Official Transcript of Proceedings ACRST-3308

Title: Advisory Committee on Reactor Safeguards  
520th Meeting

Date: Thursday, March 3, 2005

18 MEMBER APOSTOLAKIS: Thank you Mr.  
19 Chairman. The purpose of our meeting today is to  
20 review the revised draft NUREG report on estimating  
21 LOCA frequencies through the expert opinion  
22 elicitation process.

# Issues - Seismic

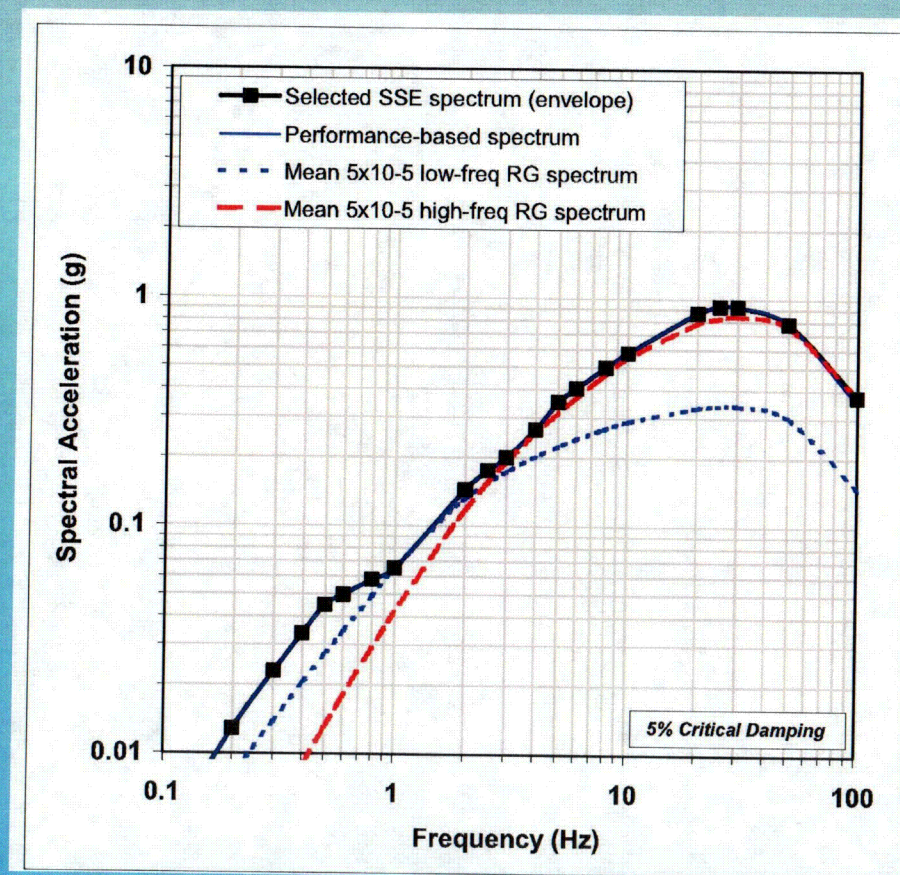
- Because staff had not reviewed or approved the performance-based approach, staff advised Dominion that time required for review of this method would likely result in delay in issuance of staff's review products for the ESP application
- Applicant ultimately elected to use RG 1.165 method with justification for use of reference probability  $5 \times 10^{-5}$  per year

# SSE vs RG 1.60

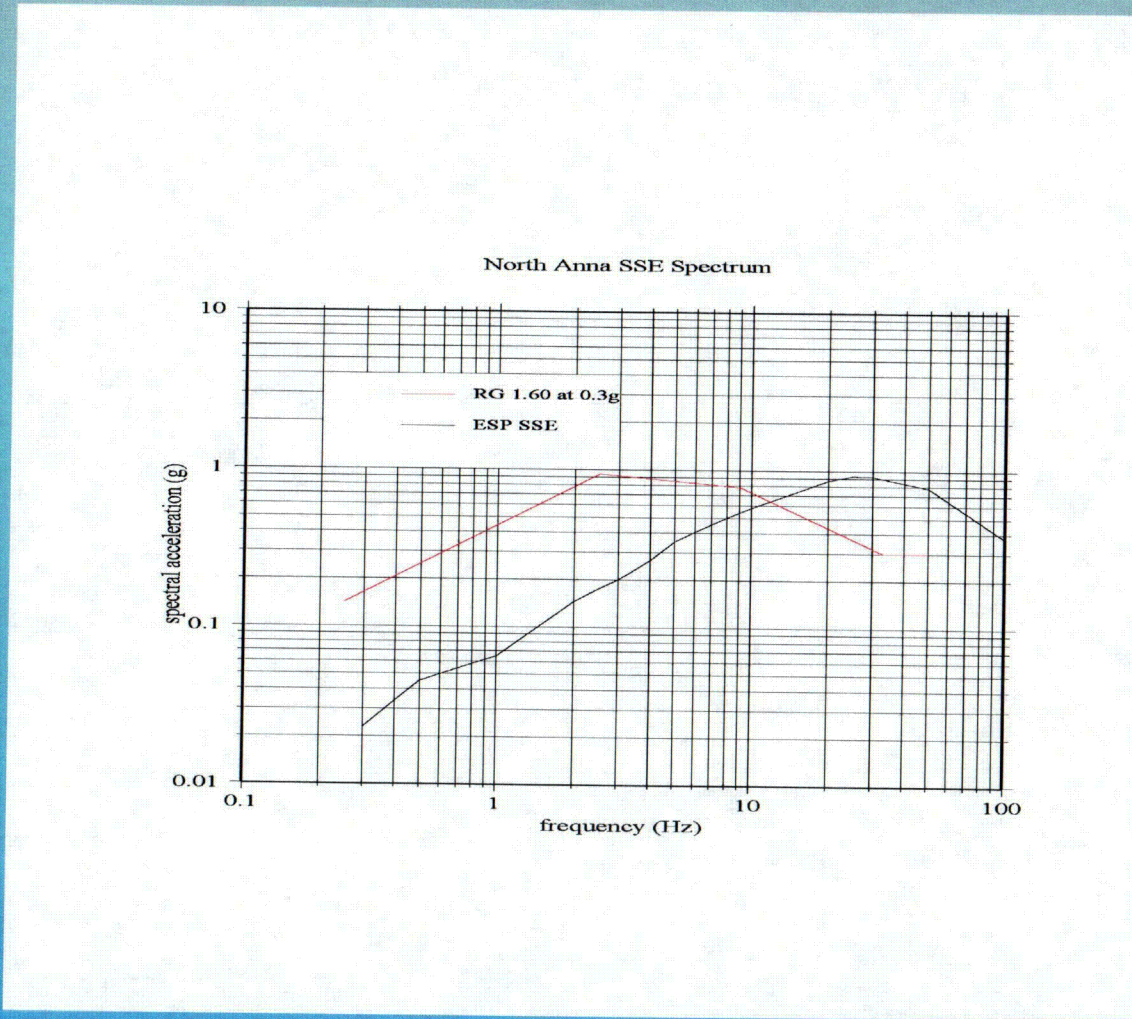
- Because North Anna is a rock site, site SSE exceeds design SSE at high frequencies for designs certified to date
- COL applicant would need to resolve disparity if one exists (dependent on design selected)
- See SSE vs. RG 1.60 diagram
